SUBJECT: HOPE CREEK GENERATING STATION - STAFF ASSESSMENT OF INFORMATION PROVIDED PURSUANT TO TITLE 10 OF THE *CODE OF FEDERAL REGULATIONS* PART 50, SECTION 50.54(f), SEISMIC HAZARD REEVALUATIONS FOR RECOMMENDATION 2.1 OF THE NEAR-TERM TASK FORCE REVIEW OF INSIGHTS FROM THE FUKUSHIMA DAI-ICHI ACCIDENT AND STAFF CLOSURE OF ACTIVITIES ASSOCIATED WITH RECOMMENDATION 2.1, "SEISMIC" (CAC NO. MF3924)

STAFF ASSESSMENT BY THE OFFICE OF NUCLEAR REACTOR REGULATION

HOPE CREEK GENERATING STATION

**Figure 3.3-1 Plot of the Staff's and Licensee's Base Case Shear-Wave Velocity Profiles for the Hope Creek site**

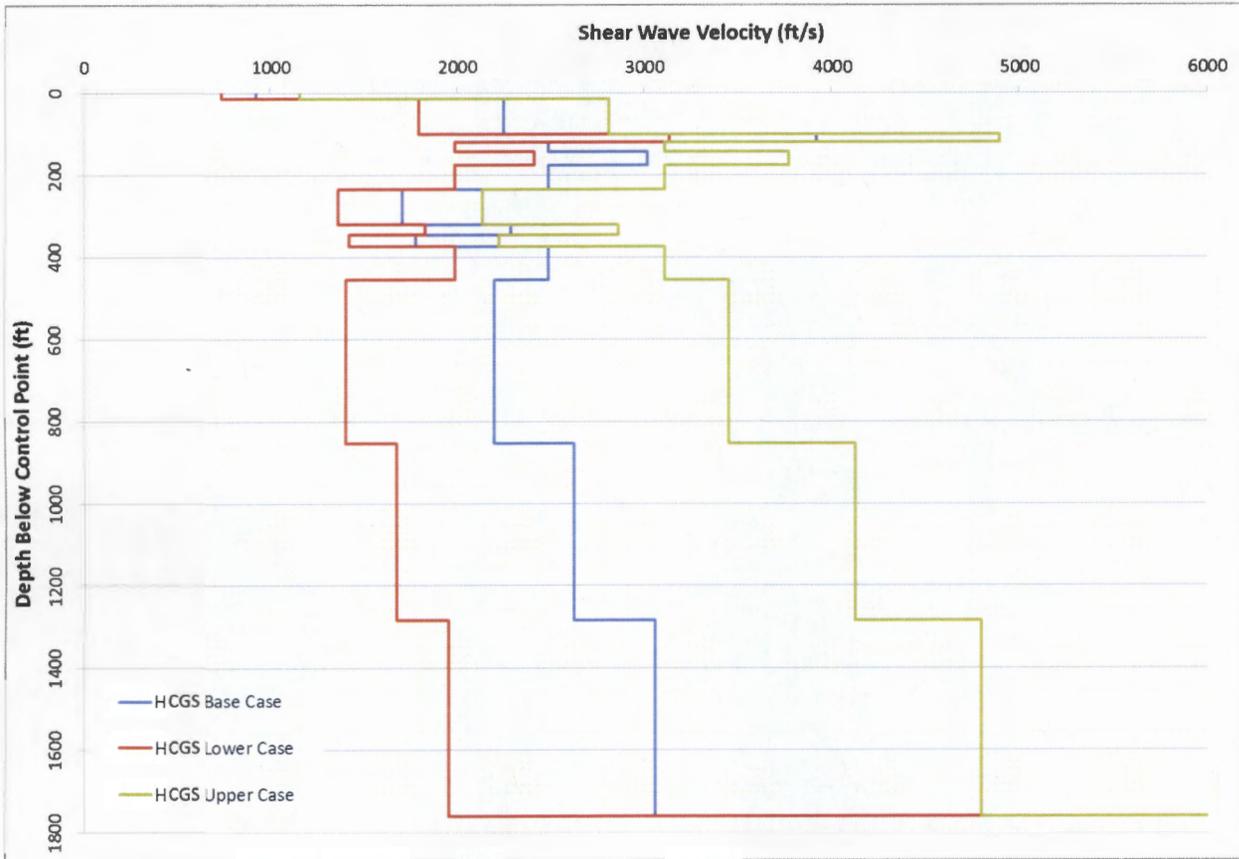
In Section 2.3.2.1 of its SHSR, the licensee describes its three base case shear-wave velocity profiles for the Hope Creek site. The licensee used a natural log standard deviation of 0.20 to calculate the lower and upper base case shear-wave velocity profiles to a depth of approximately 516 ft (157 m) and a natural log standard deviation of 0.35 to calculate the lower and upper base case shear-wave velocity profiles from 516 ft (157 m) depth to bedrock at 1,800 ft (548 m). Table 2-2 and Figure 2-1 of its SHSR provide the licensee's shear-wave velocity profile for each of the three base cases. Figure 3.3-1 of this assessment shows the licensee's three shear-wave velocity base case profiles.

Because the site is well characterized and the velocities are reported in the PSEG ESPA (PSEG, 2013), the NRC staff used the same three base case shear-wave velocity profiles that were used by the licensee for its site response analysis. However, to capture the uncertainty in the depth to base rock, the NRC staff used a value of  $\pm 106$  ft [ $\pm 32$  m], which is less than the  $\pm 510$  ft ( $\pm 155$  m) depth to base rock randomization used by the licensee. Figure 3.3.-1 of this assessment illustrates the velocity profiles the NRC staff used in its confirmatory analysis.

**Figure 3.3-2 Plot Comparing the Staff's and the License's Median Amplification Functions and Uncertainties for two input loading levels for the Hope Creek site**

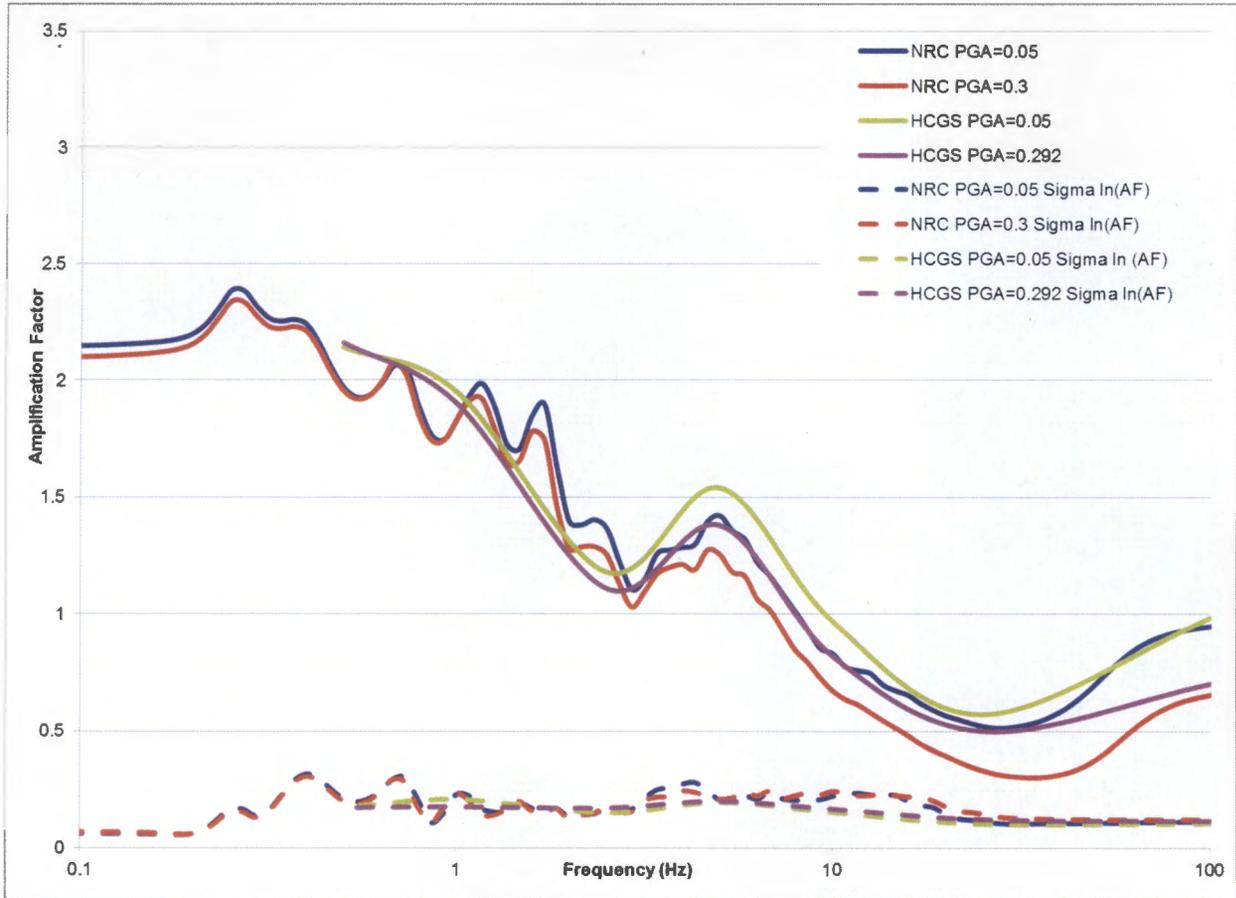
Figure 3.3-2 of this assessment shows a comparison of the NRC staff's and licensee's median site amplification factors and uncertainties ( $\pm 1$  standard deviation) for 2 of the 11 input loading levels. The staff's median site amplification factors are similar to the licensee's.

Figure 3.3-3 Plot Comparing the Staff's and the Licensee's Mean Control Point Hazard Curves at a Variety of Frequencies for the Hope Creek site

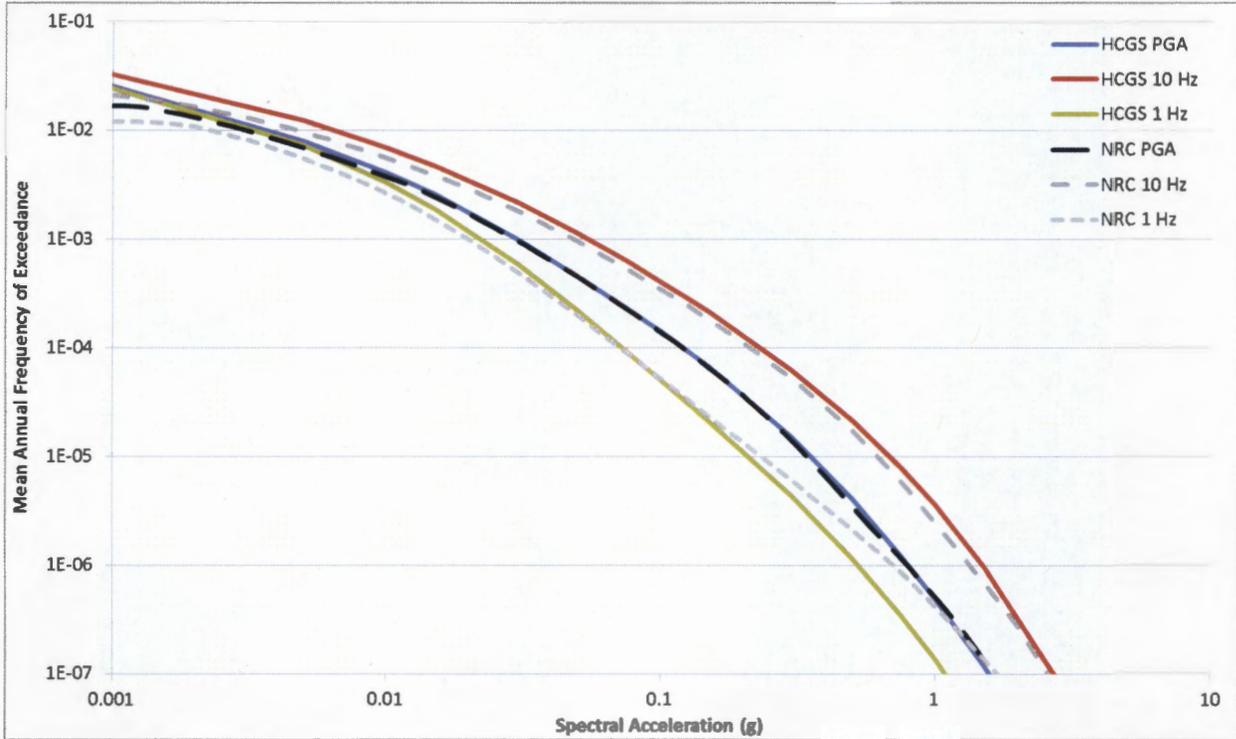
Overall, the licensee's approach to modeling the subsurface rock properties and uncertainties results in similar site amplification factors to the NRC staff's site amplification factors. Additionally, as shown in Figure 3.3-3 of this assessment, the NRC staff notes that the slight differences in the site response analysis do not have a large impact on the control point seismic hazard curves or the resulting GMRS, as discussed below. Appendix B of the SPID provides guidance for performing site response analyses, including capturing the uncertainty for sites with less subsurface data; however, the guidance is neither entirely prescriptive nor comprehensive. As such, various approaches in performing site response analyses, including the modeling of uncertainty, are acceptable for the 50.54(f) response.

Figure 3.4-1 Comparison of the Staff's GMRS, Licensee's GMRS, Hope Creek site SSE, and the Hope Creek site IHS for the Hope Creek site

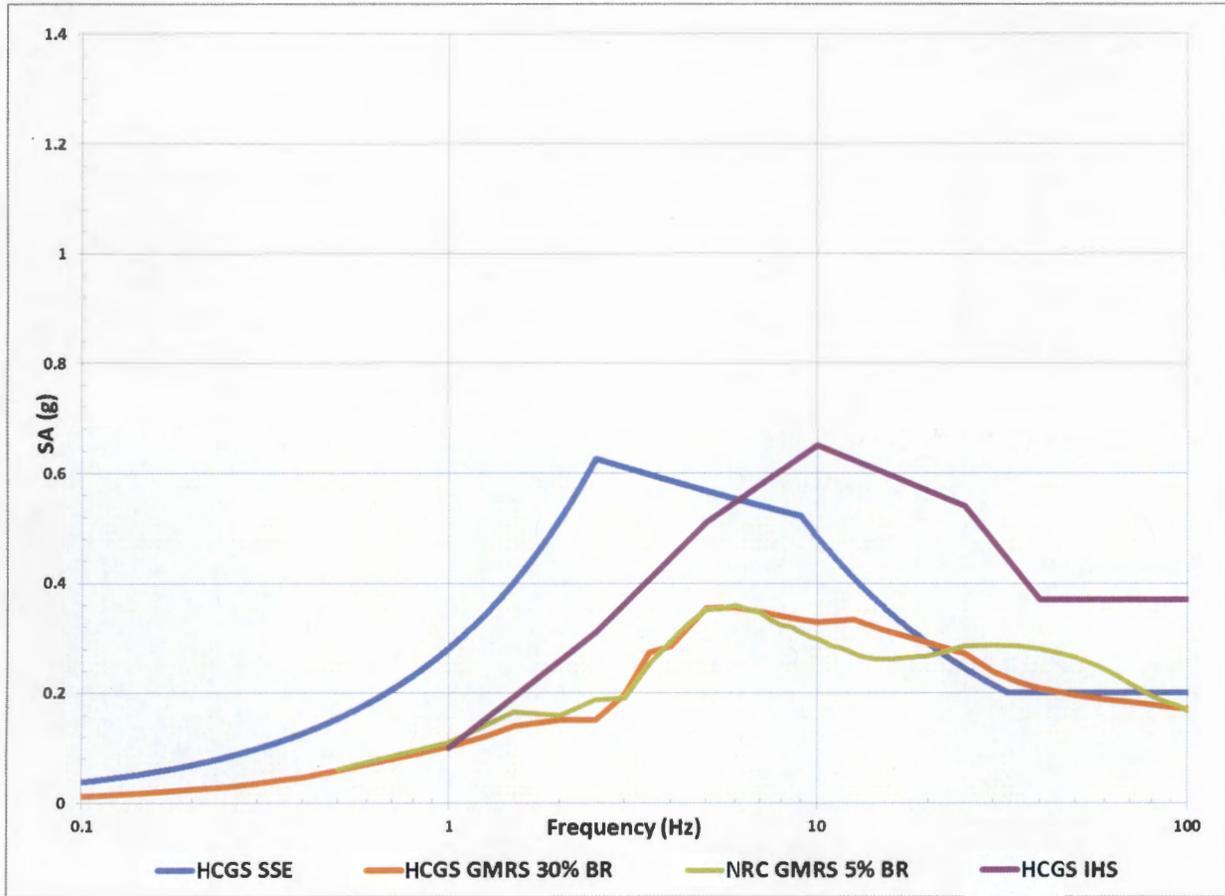
The NRC staff independently calculated the  $10^{-4}$  and  $10^{-5}$  UHRS using the results of its confirmatory PSHA and site response analyses, as described in Sections 3.2 and 3.3 of this staff assessment, respectively. Figure 3.4-1 of this assessment shows a comparison of the GMRS determined by the licensee to that determined by the NRC staff.

As shown in Figure 3.4-1 of this assessment, the licensee's GMRS shape is generally similar to that calculated by the NRC staff at frequencies less than 10 Hz. However, NRC staff's confirmatory GMRS is somewhat higher than the licensee's at frequencies above 10 Hz. As described above in Section 3.3, the NRC staff concludes that these minor differences over the higher frequency range are primarily due to the differences in the site response analyses performed by the licensee and the NRC staff. The NRC staff concludes that these differences are acceptable for this application because the licensee followed the guidance provided in the SPID with respect to both the PSHA and site response analysis for the Hope Creek site.

The NRC staff confirms that the licensee used the present-day guidance and methodology outlined in RG 1.208 and the SPID to calculate the horizontal GMRS, as requested in the 50.54(f) letter. The NRC staff performed both a PSHA and site response confirmatory analysis and achieved results consistent with the licensee's horizontal GMRS. As such, the NRC staff concludes that the GMRS determined by the licensee adequately characterizes the reevaluated hazard for the Hope Creek site. Therefore, this GMRS is suitable for use in subsequent evaluations and confirmations, as needed, for the response to the 50.54(f) letter.
